# GENERAL APPLICATION

Explanation of Request: DESIGN AND SITE PLAN APPROVAL FOR A MIXED USE DEVELOPMENT INCLUDING 2,357 SF OF COMMERCIAL AND 36 RESIDENTIAL UNITS

## PRELIMINARY TAC RESPONSE TO COMMENTS

SUBMITTAL: CITY OF HOLLYWOOD TECHNICAL ADVISORY COMMITTEE  
DATE: Monday, March 3, 2025

ENLARGED  
SITE PLAN -  
LEVEL 2  
PARKING

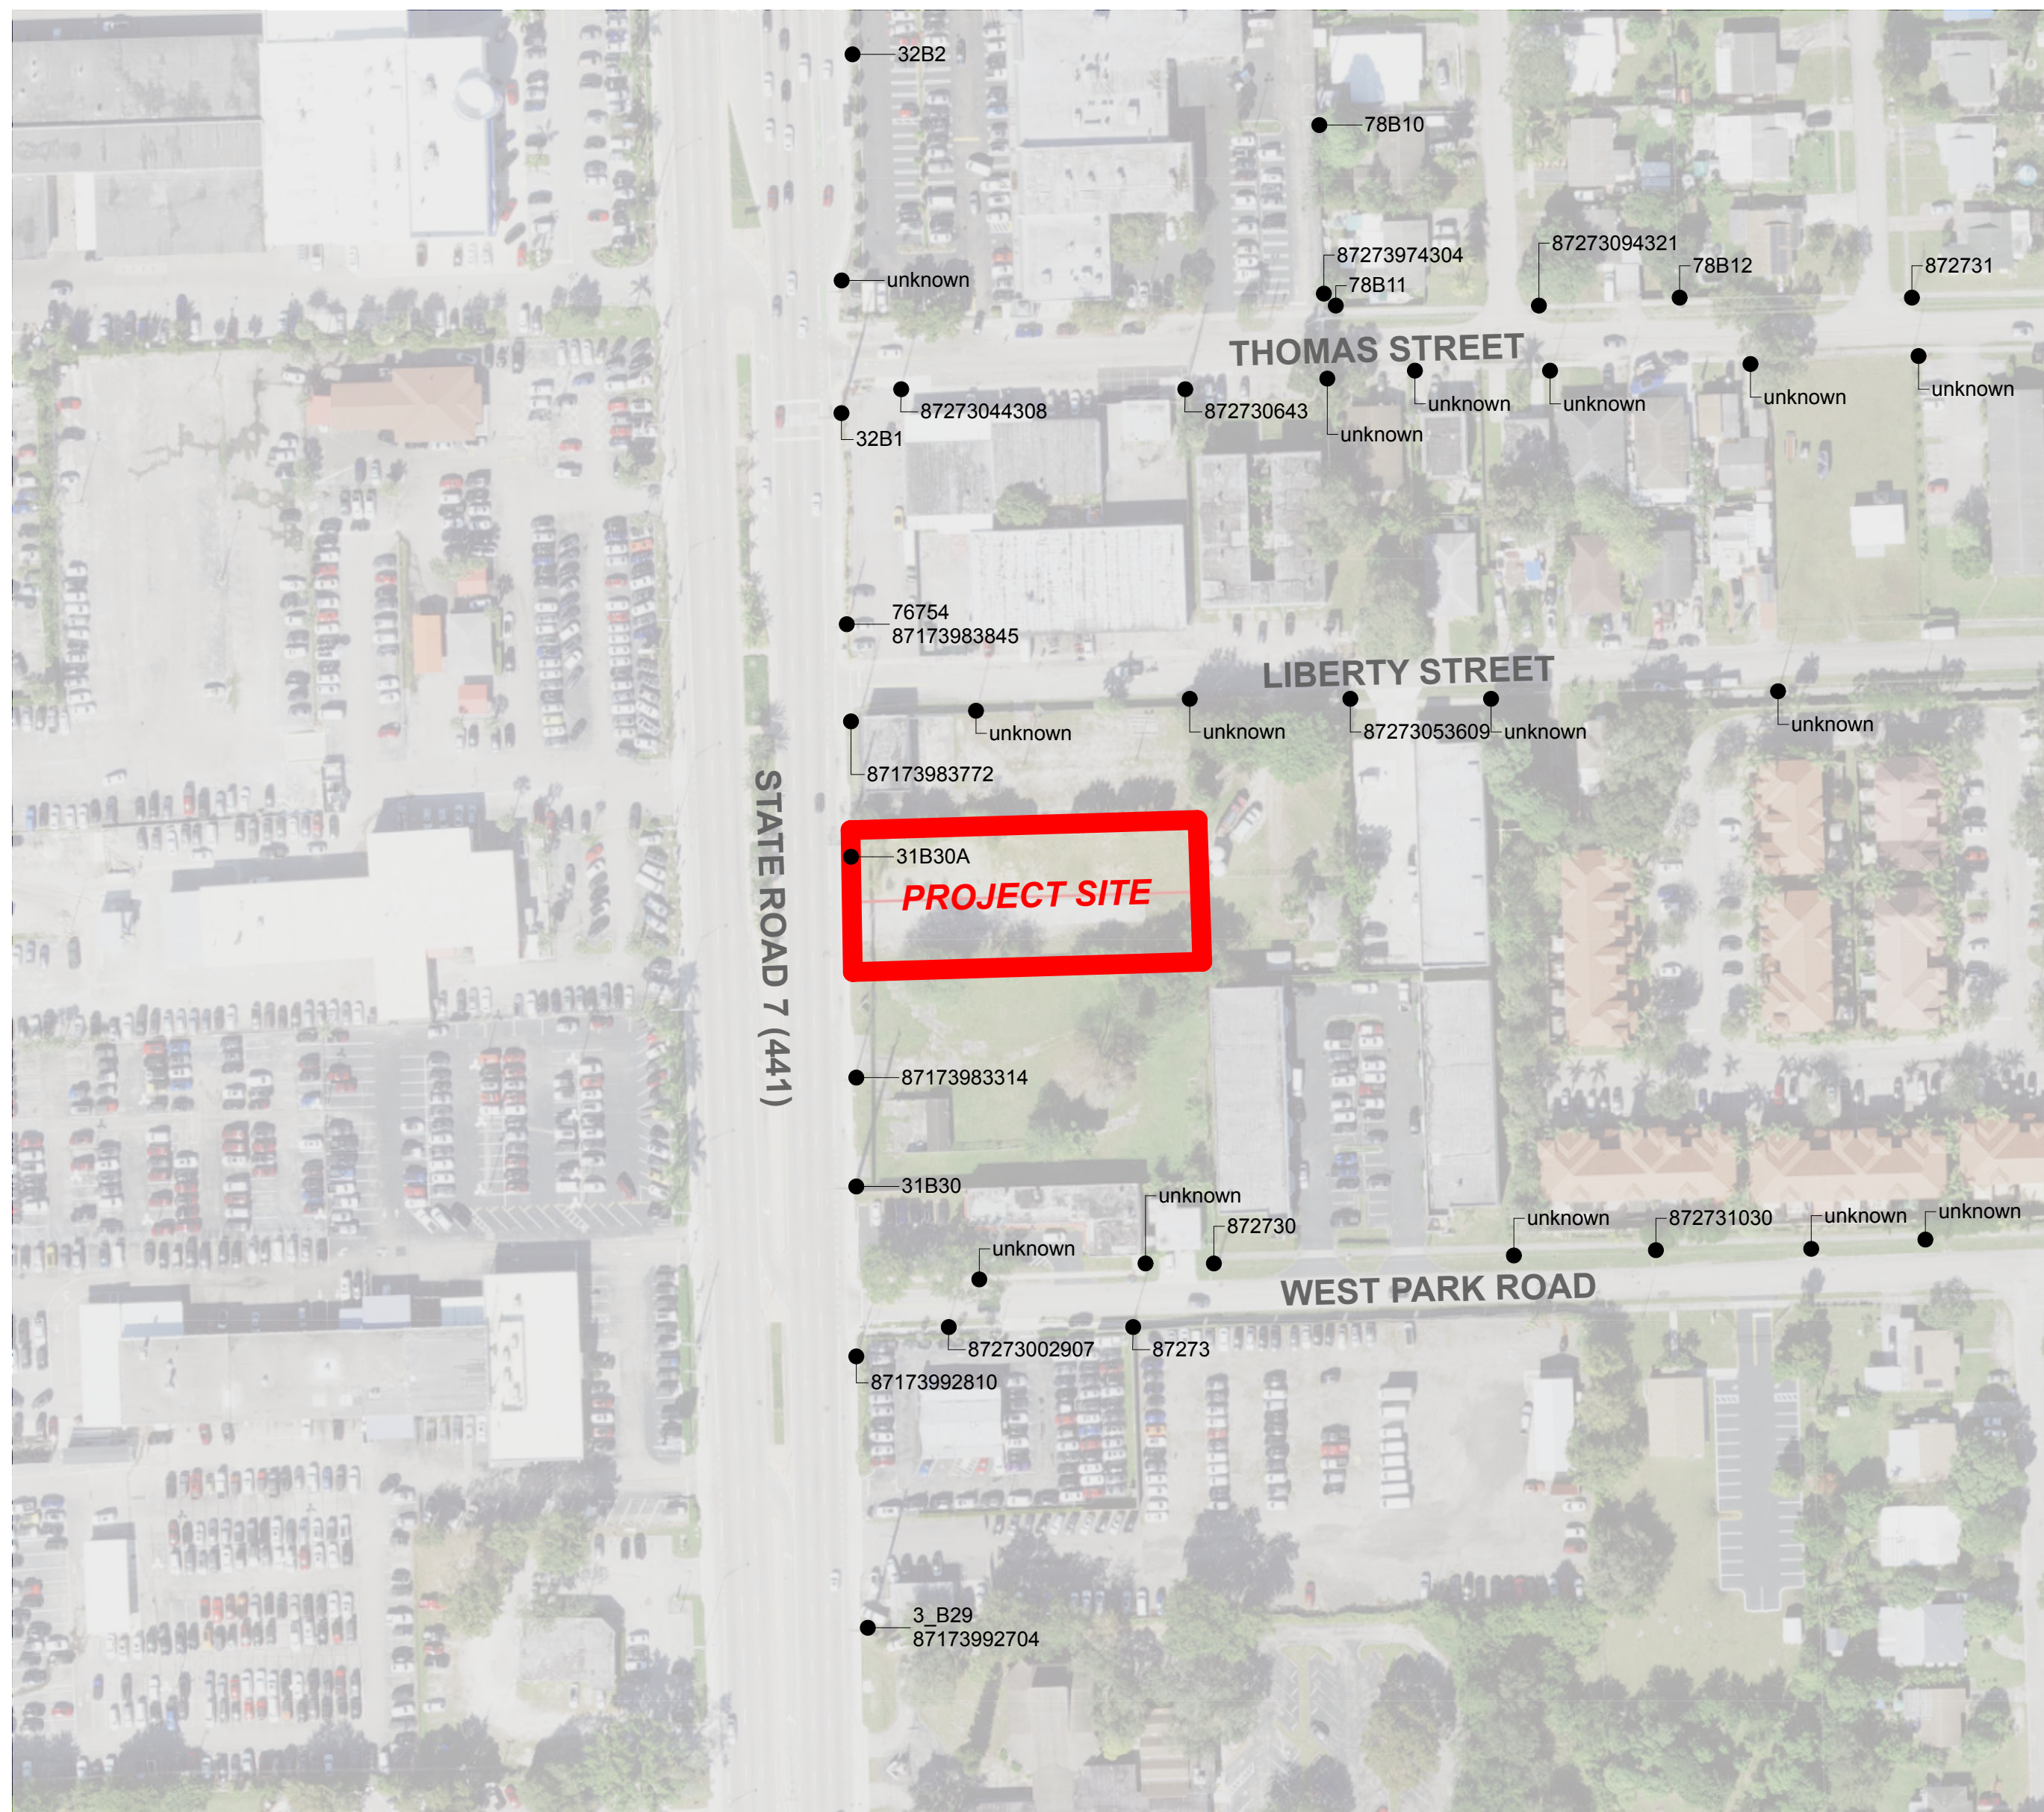
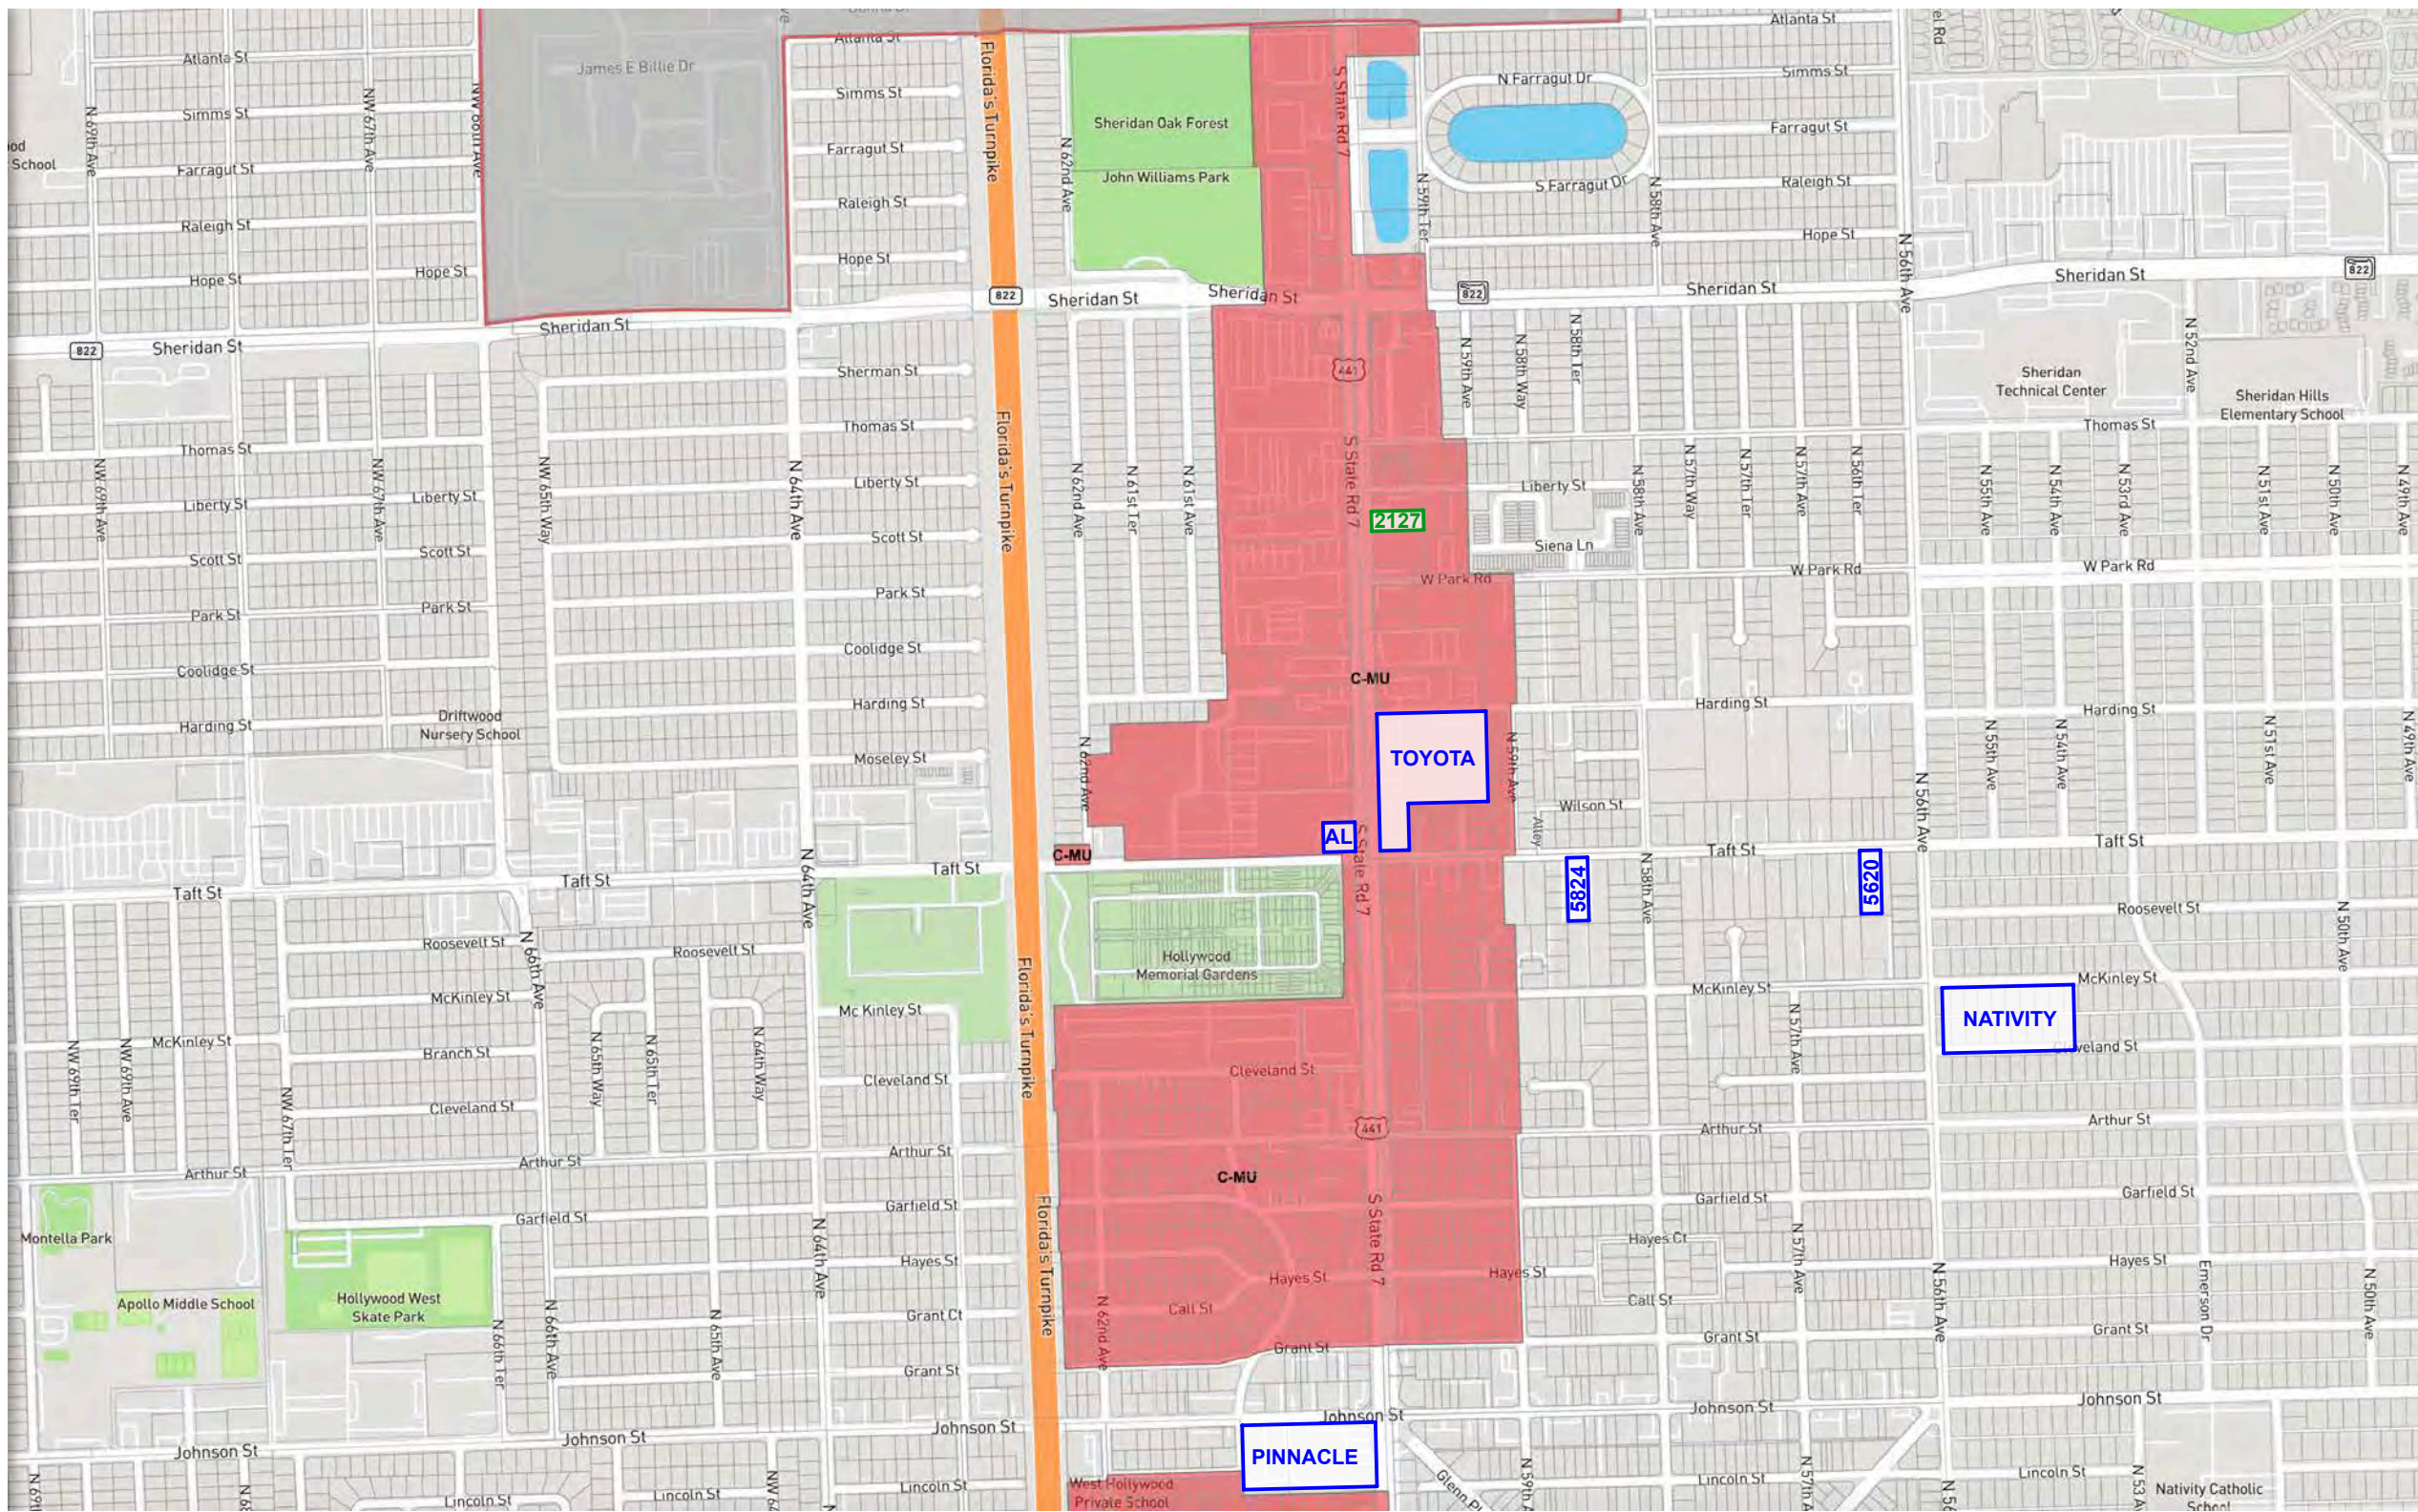
16) Provide dimensions for the column setback from the entrance of the parking stall, a minimum distance of 3' between the face of the column and drive aisle is required. Please make sure to dimension the setbacks for the columns in the 'islands' on Sheet A101 and A102.

38) Please identify the slope of all proposed vehicular ramps. Typical and recommended slopes should not exceed 12%. Show ramp slopes for all levels of the garage. Identify any transitional landings as well if applicable.

**RESPONSE: Dimensions for column setback provided on enlarged site plans, Sheet A005 and A006.**

**RESPONSE: Garage slope ramps identified. On sheets A005 and A006.**
